To: Prowest
Job: Horace Mann New Classroom Building
COR # 20
RE: IB # 026
Scope: To raise the parapet wall 2'-0" around the Gym and to add walls from 15' to 18' which includes framing sheathing and plaster per Instruction Bulletin # 026.

INSTRUCTION BULLETIN: 026

PROJECT:
 HORACE MANN NEW CR
 WING AND UNDERGROUND
 PARKING

Change Proposal Request #073

Attachments: AB4.2, 1/ABS.1, 2/ABS.2 & REVIT MODEL

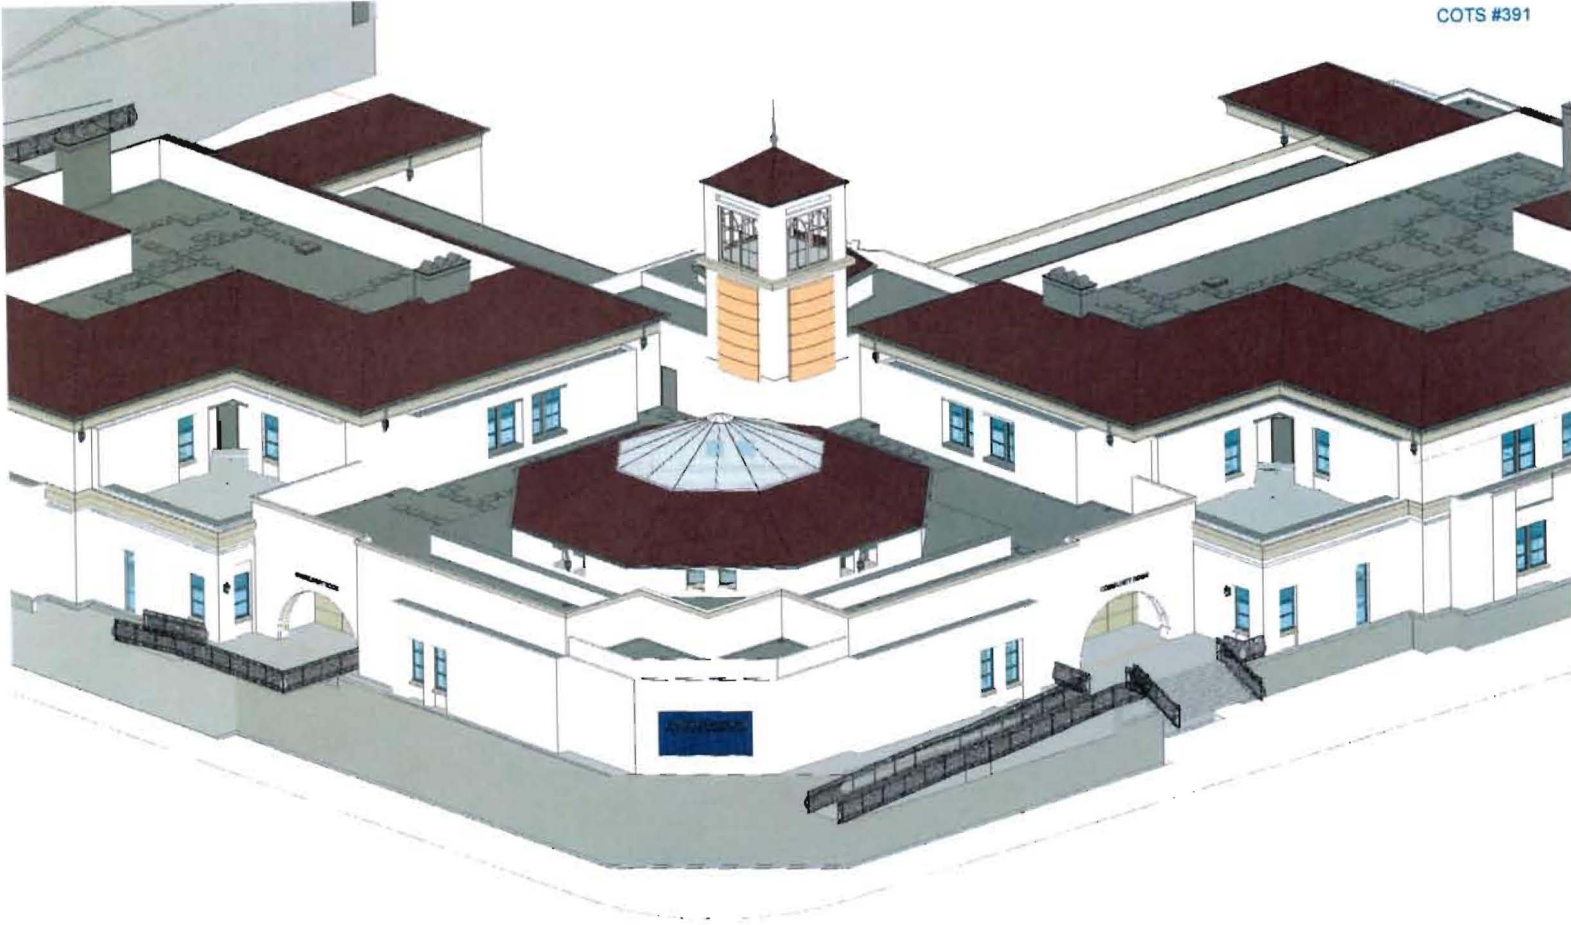
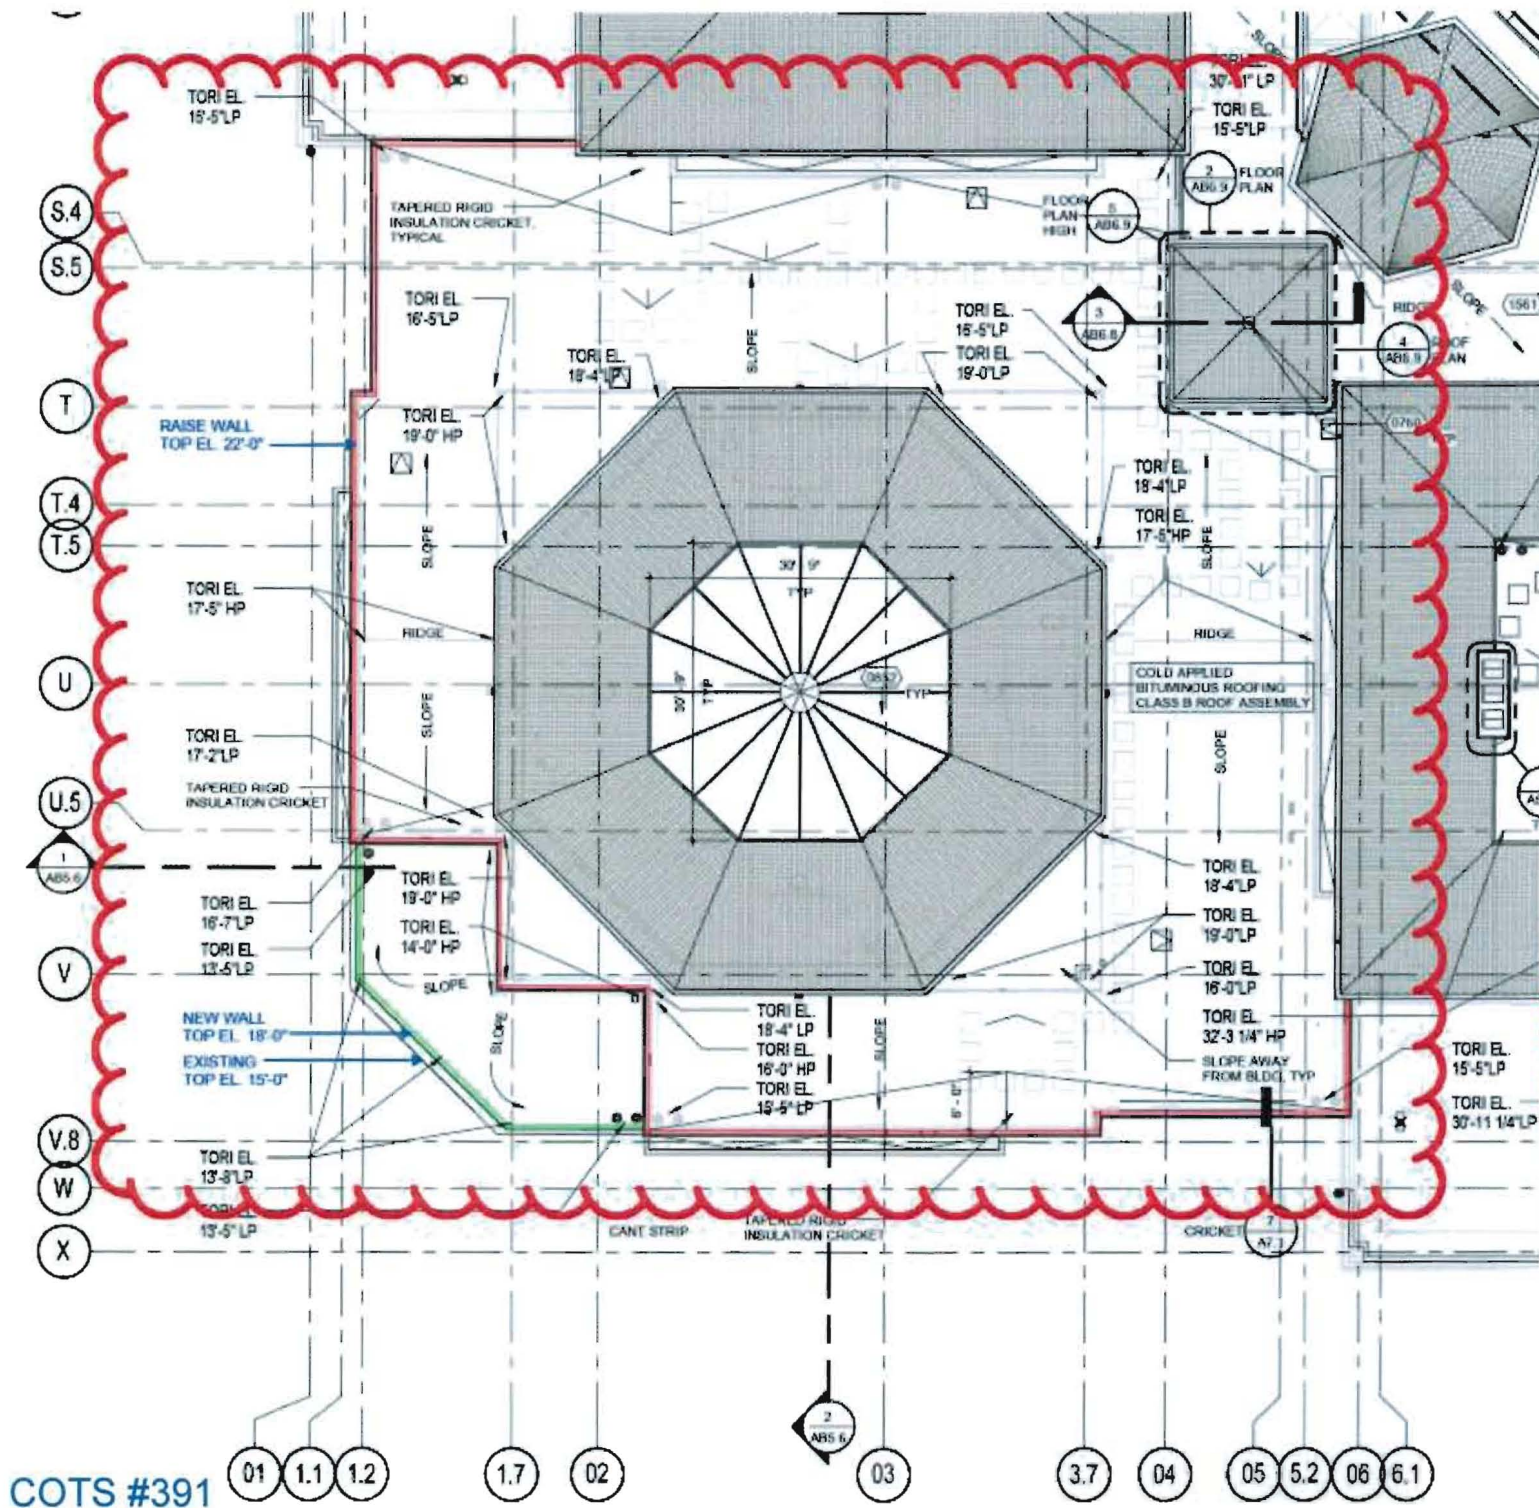
Item 26.1 RAISE PARAPET WALL FROM EL. 20'-0" TO EL. 22'-0"
 AND ADD NEW PARAPET WALL TO EL. 18'-0" AS PER
 STRUCTURAL DETAILS 13/SB7.11 AND 5/SB7.12
 AS SHOWN ON ATTACHED SHEETS AB4.2, 1/ABS.1, 2/ABS.2
 AND REVIT MODEL.

FISCHER REF # 006
ATTACHMENT # 3

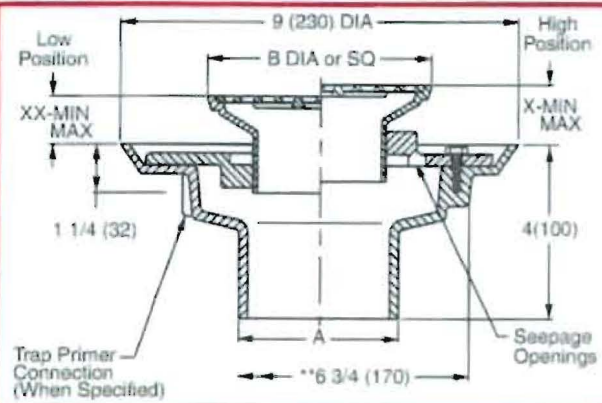
1. Attachments # 1 - 2 show the scheduled and approved AD-1 gutter drain fitting and no hub adapter and Attachment # 3 shows approved FD-1. We recommend upgrading to the FD-1 fixture in lieu of the JR Smith Figure 1610T and 2646Y fittings that are not specifically intended to be used as deck drains.

Model 1619T listed on the Plumbing Fixture Schedule does not exist. Model 1610T shown here is the closest model they had to the description in the plumbing fixture schedule which was provided by a Jay R. Smith customer service representative.

- 1.- ATTACHMENT #1-3 PROVIDE J.R. SMITH DX-20054 TYPICAL, IN LIEU OF SPECIFIED AD-1 J.R. SMITH 1619T WITH 20464 ADAPTER.
- 2.- ATTACHMENT #4 AD-1 AT GRIDS G-8 & V-X.5 IN SECOND FLOOR ROUTE 3" 40 PIPE IN CEILING OF FIRST FLOOR TO 4" SD AT GRID 8.7-X.5. AND SPILL TO CURB AS SHOWN IN ATTACHMENT #8
3. ATTACHMENT #5 ALL PIPING FROM AD-1 SHALL BE 3"
- 4.- ATTACHMENT #6 SHOWS ROUTING OF AREA DRAIN PIPING AND NOTE NO. 7 READS (2" SD FROM DECK DRAIN ABOVE) NOTE (7) SHOULD BE REVISED TO READ "3" 40 DOWN TO CEILING OF FIRST FLOOR FROM DECK DRAIN IN FLOOR ABOVE"

FISCHER RFI # 006
ATTACHMENT # 7

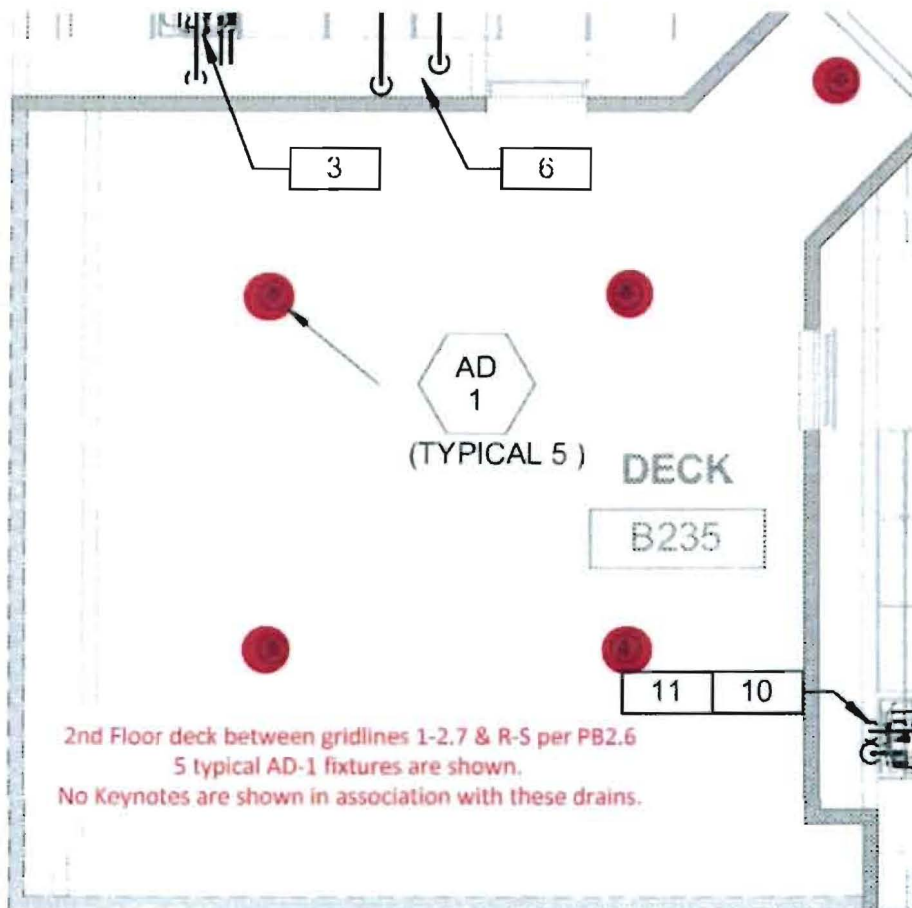
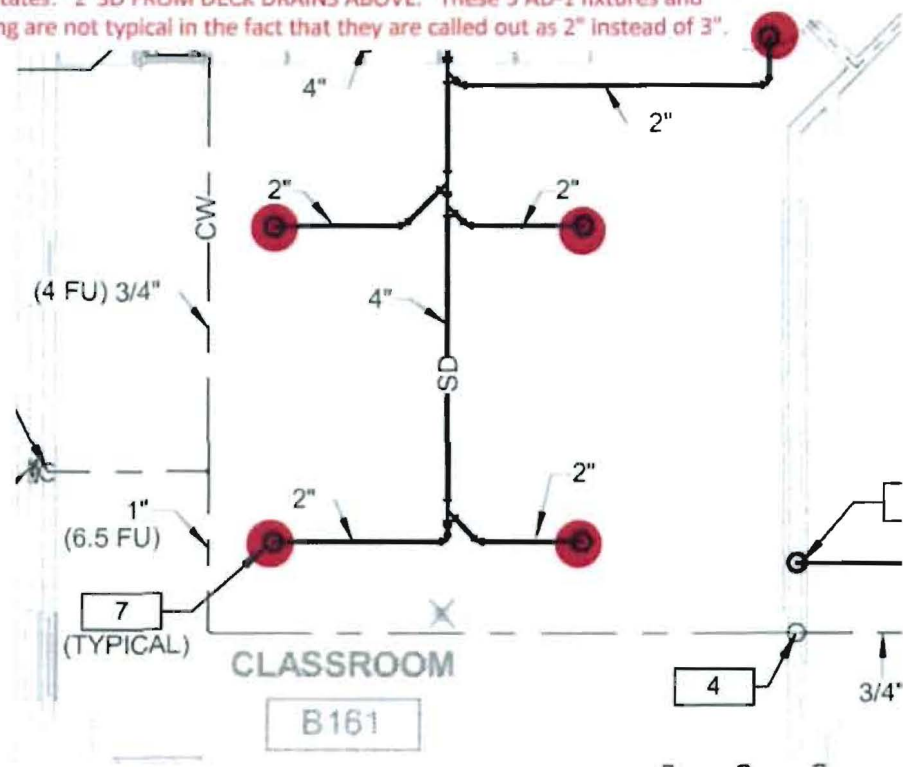
5. Attachment # 7 shows First Floor Area B Plumbing Plan PB2.4 and Second Floor Area B Plumbing Plan PB2.6 between gridlines 1-2.7 & R-S. 5 typical AD-1 drains are shown on the second floor and 2" drain lines connecting to a 4" main line is shown for the Level 1 overhead. Keynote # 7 states: "2" SD FROM DECK DRAINS ABOVE." This is also in conflict with AD-1 which is 3" as well as the 3" drains and piping shown in Attachment # 5.

1st Floor below the deck between gridlines 1-2.7 & R-S per PB2.4
Pipe is shown and size is indicated as 2" for the 5 typical AD-1 fixtures.
Keynote # 7 states: "2"SD FROM DECK DRAINS ABOVE." These 5 AD-1 fixtures and associated piping are not typical in the fact that they are called out as 2" instead of 3".

- 5.- ATTACHMENT 7, REVISE NOTE NO. 7 TO READ "3" SD DOWN TO CEILING OF FIRST FLOOR FROM DECK DRAIN IN FLOOR ABOVE" IN LIEU OF "2" SD FROM DECK DRAINS ABOVE"
6. ATTACHMENT 8, WE HAVE REVIEWED ATTACHMENT 8 AND WE TAKE NO EXCEPTIONS.

Suggested piping sizing and layout for the missing piping from Attachment # 4

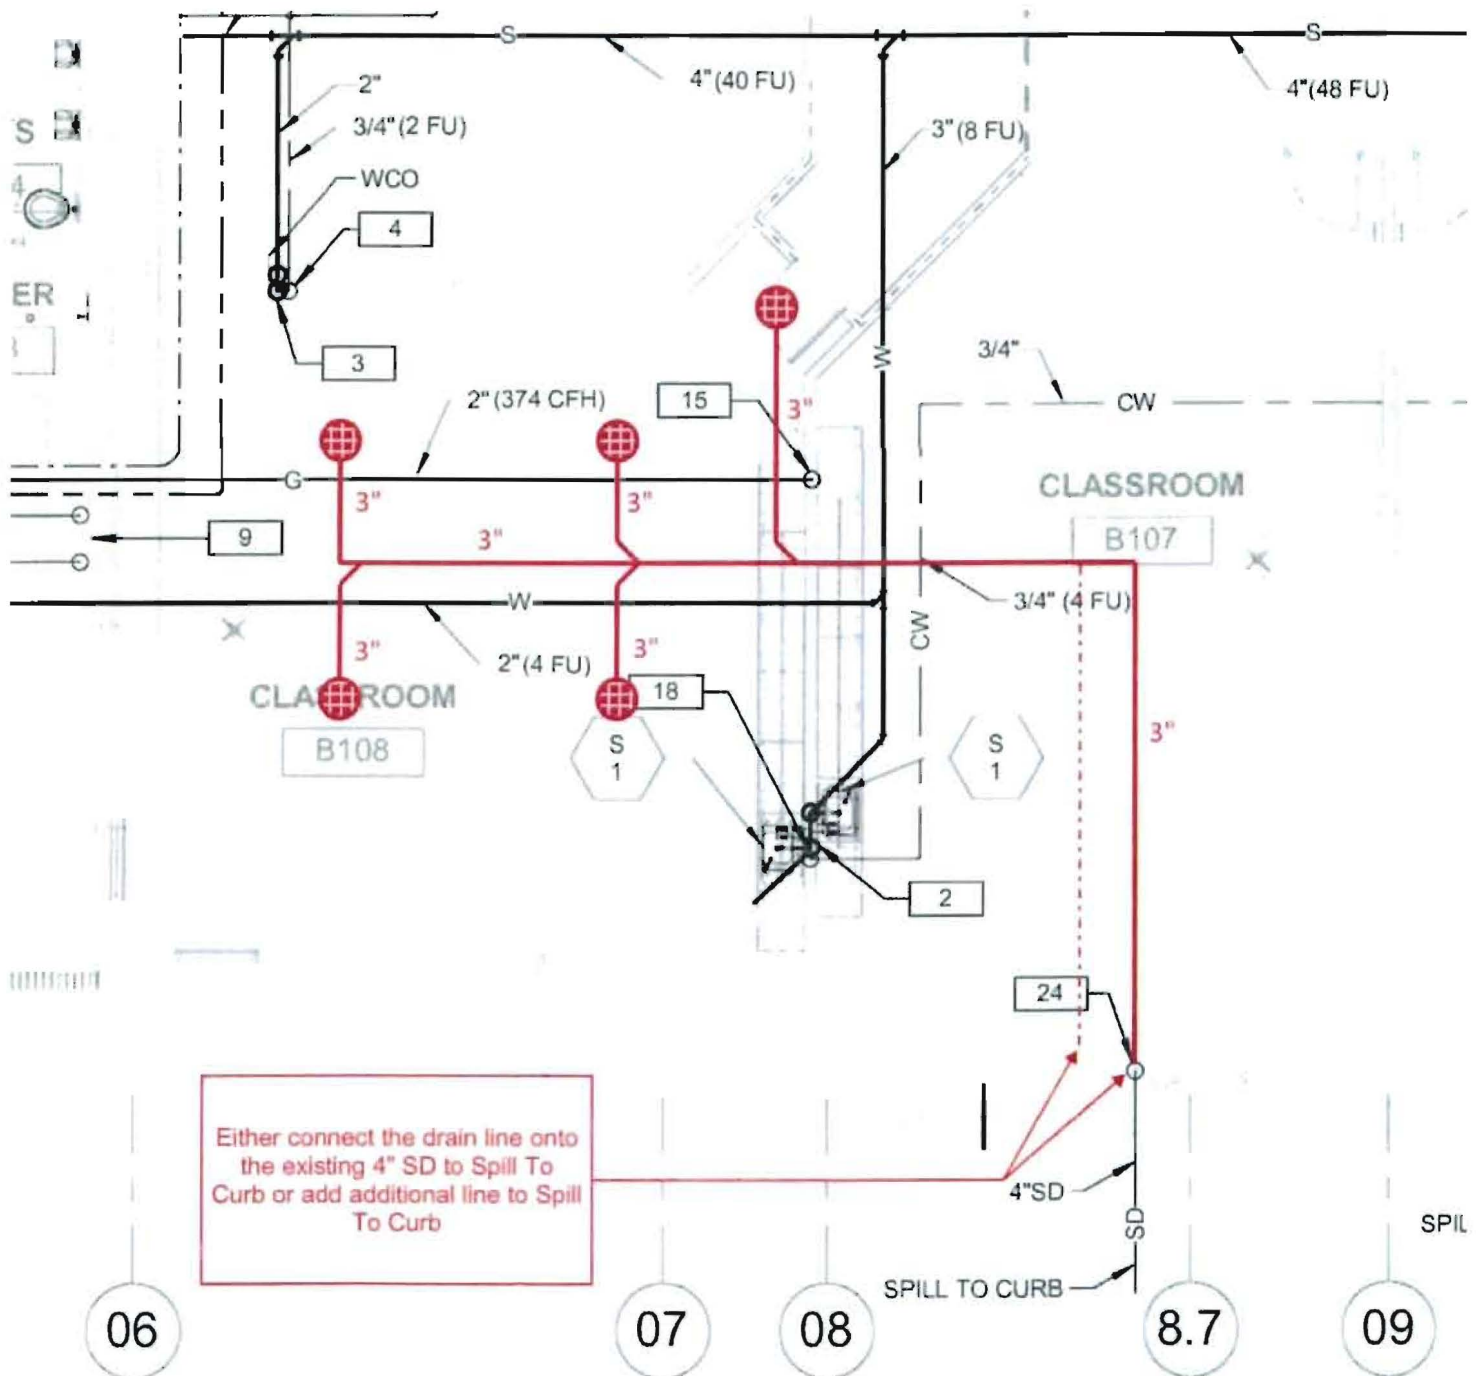
6. Attachment # 8 is a suggested pipe sizing and routing for the missing pipe for the 5 area drains from item 2 above. (Attachment # 4)

BASMENT FLOOR
PLAN SOUTH GARAGE
DRAWING NUMBER: **AB2.2**

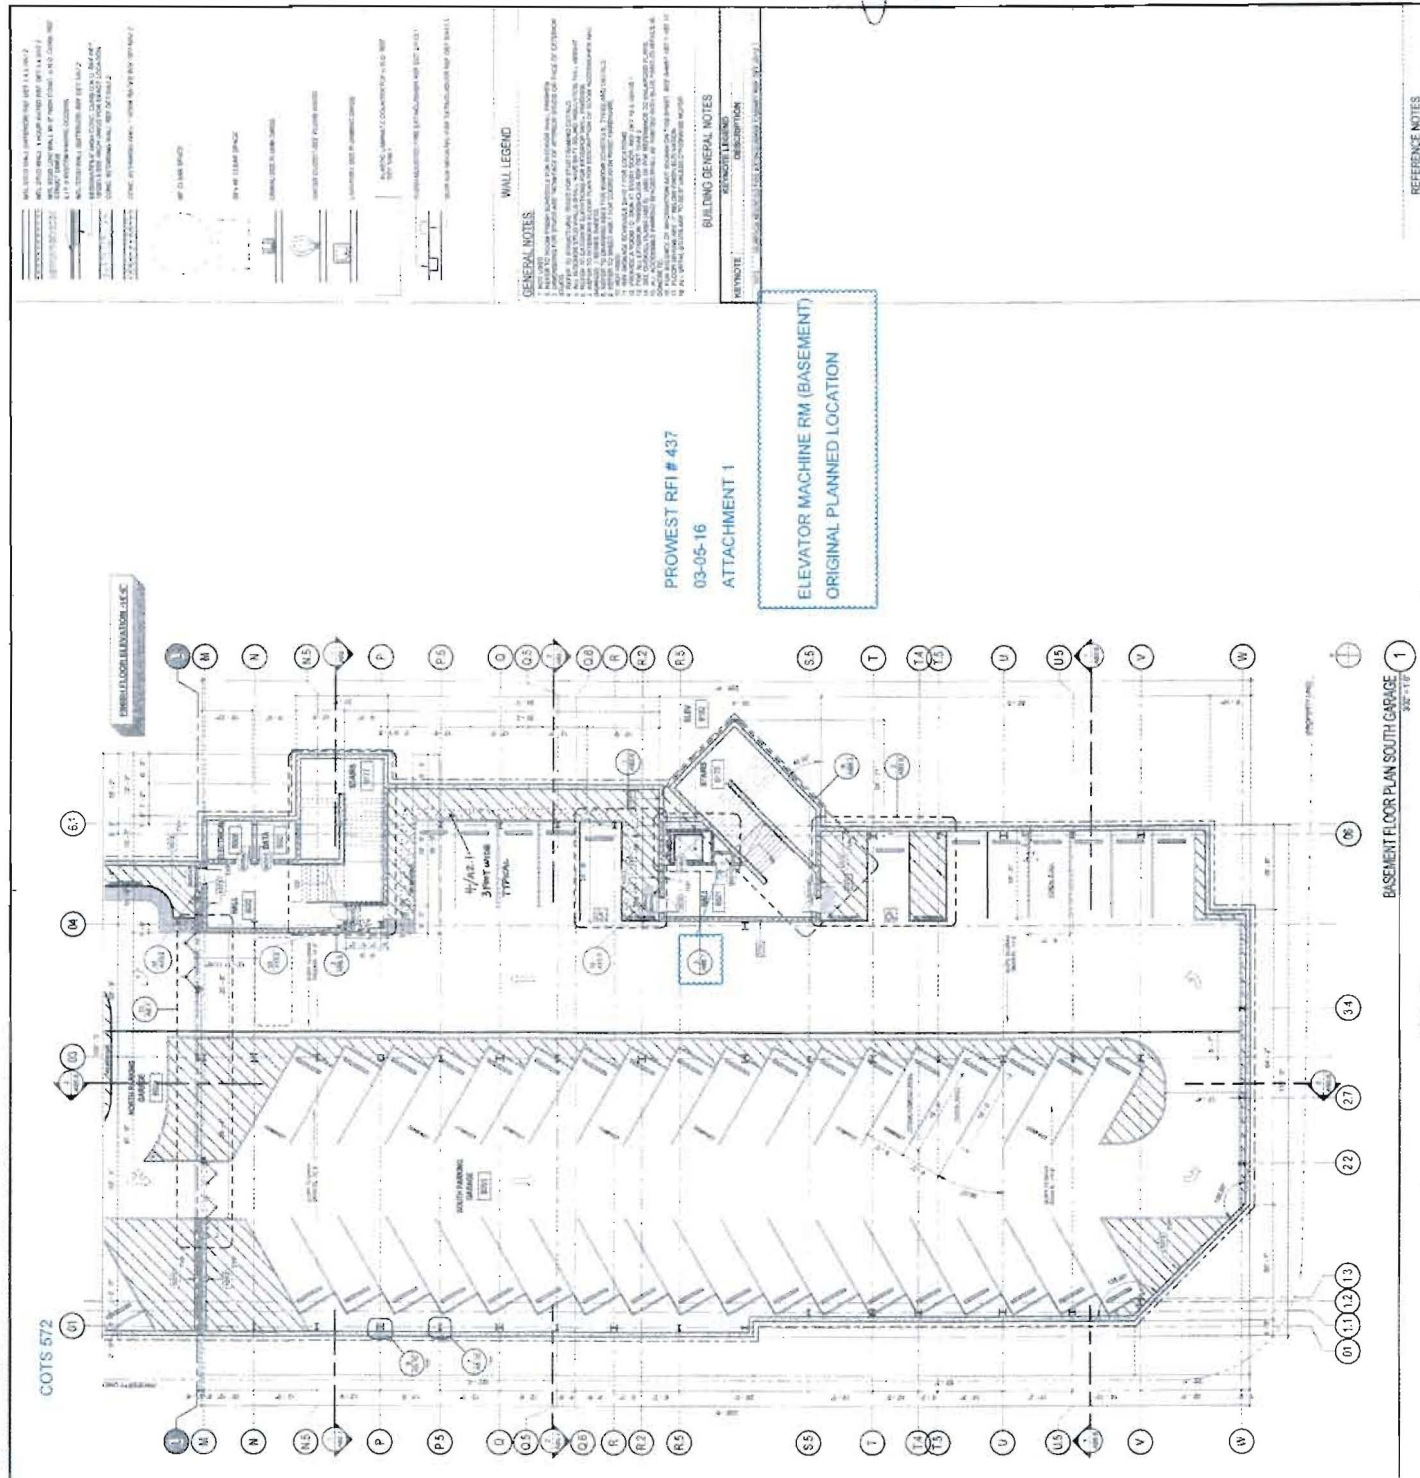
Due to the relocated Elevator B182 Machine RM (Submittal #137); which had planned location at Basement FL, adjacent to Hall RM B001 (Attachment 1); to the new location on First FL Storage B153 (DSA Deferred Submittal #137 (Otis Elevator) - Attachment 2.; are proceeding with relocating the electrical & mechanical systems to accommodate elevator gear & equipment (Attachment 3). Our mechanical sub (Air Flow) is proposing to relocate Fan Coil Unit (FC-5) to match the installation of Fan Coil Units (FC 1-4) Wall Mounted Units (Attachment 3). This Basement FL Fan Coil Unit (FC-5) is a ducted fan coil; while Fan Coil Units (FC 1-4) are wall mounted, ductless units. Is it acceptable to switch FC-5 to a ductless fan coil, matching the same model for units FC 1-4, due to Elevator Machine RM relocation to First FL Storage RM B153, noted on the approved Submittal #137? Please advise.

Change Fan Coil Unit FC-5 to ductless unit (match FC 1-4 TYP); and install to the new location on First FL Storage B153 (DSA Deferred Submittal #137 (Otis Elevator).
